**SECTION 00 9111**  
**ADDENDUM NUMBER 01**

DATE: January 2, 2025  
PROJECT: 2025 Roof Replacements  
PROJECT NUMBER: 2240017800  
OWNER: Southeast Polk Community School District  
ARCHITECT: Shive-Hattery, Inc.

**A102 – ROOF PLAN, NOTES & DETAILS – JR HIGH SCHOOL**

**6A ROOF CURB DETAIL**  
3" = 1'-0"

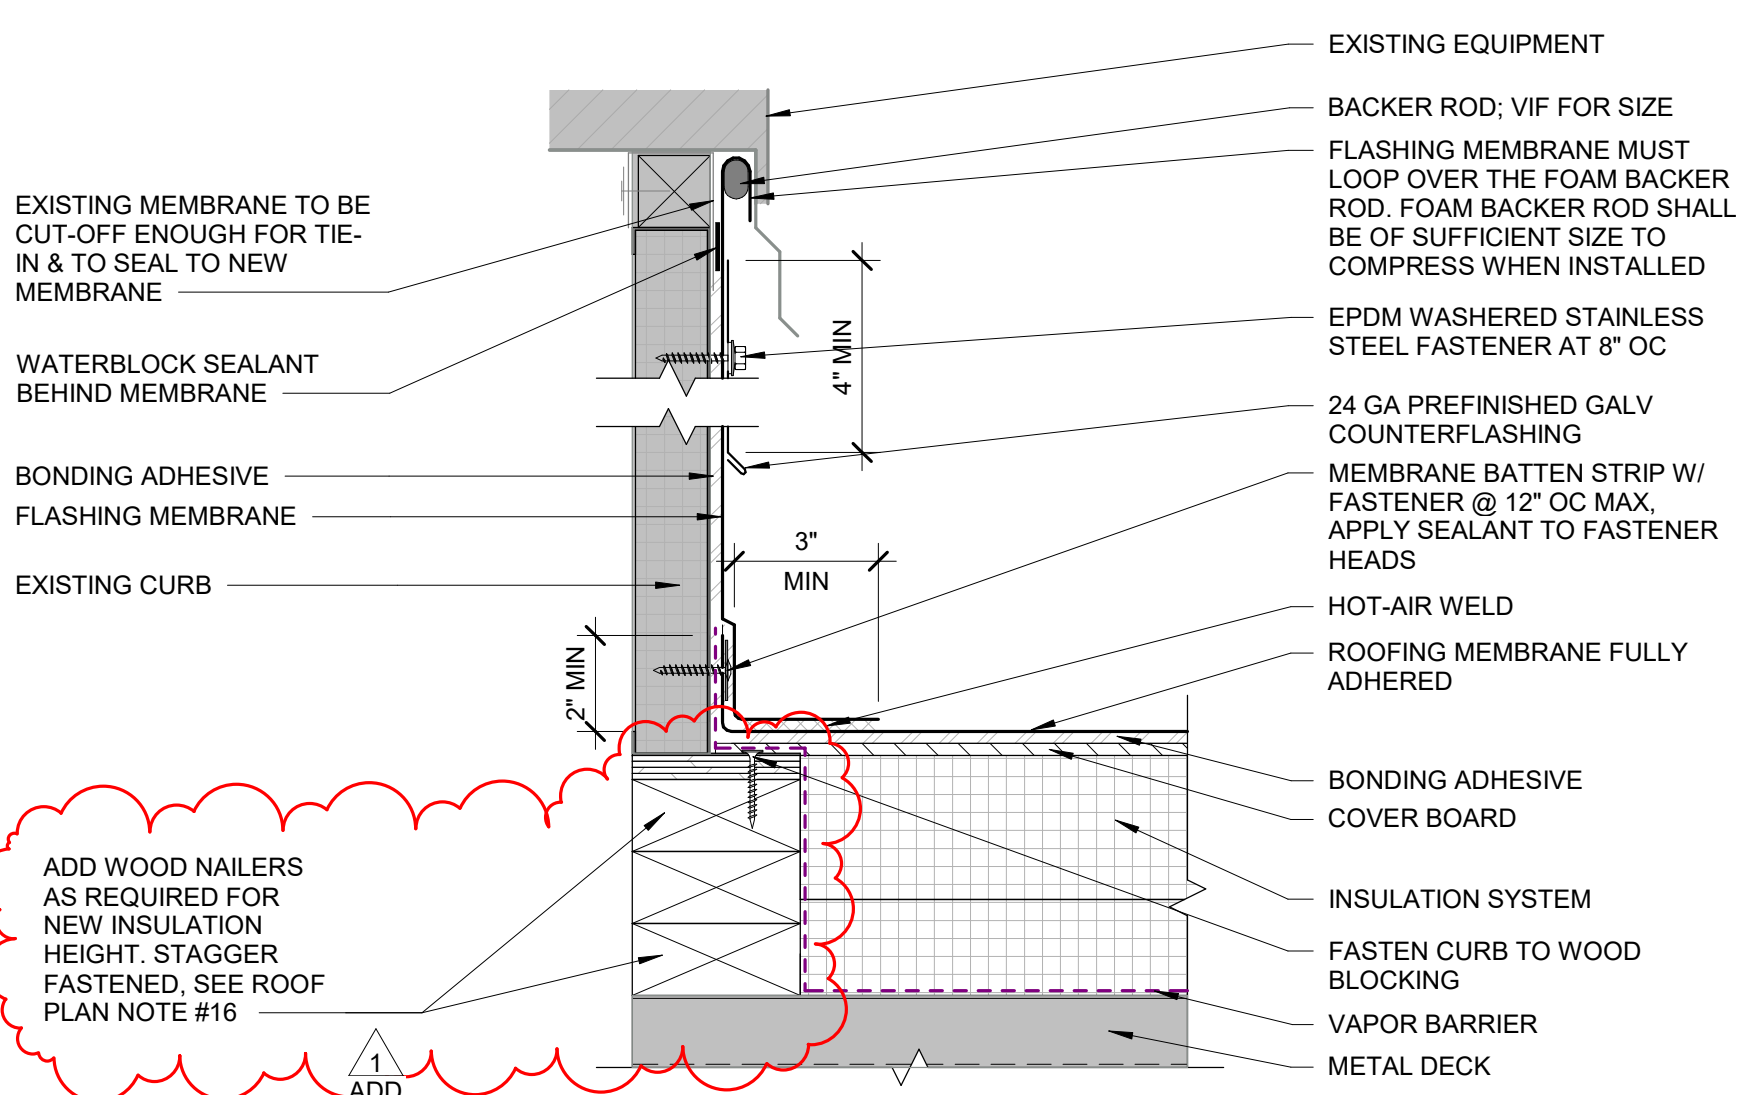
1. Pre-bid Meeting Summary and Sign-In Sheet are attached to this addendum.
2. **Q:** The contractor warranty for EPDM is 2 years but the PVC contractor warranty is shown at 5 years. Can we make these both 5 years to match?  
**A:** Contractor warranties for both EPDM and PVC should be 5 years. See revision to specification below.
3. **Q:** Should curbs for the existing smoke vents at the Junior High be raised?  
**A:** See revisions to sheet A102.

5. **REPLACE** detail 6A with attached revised detail.
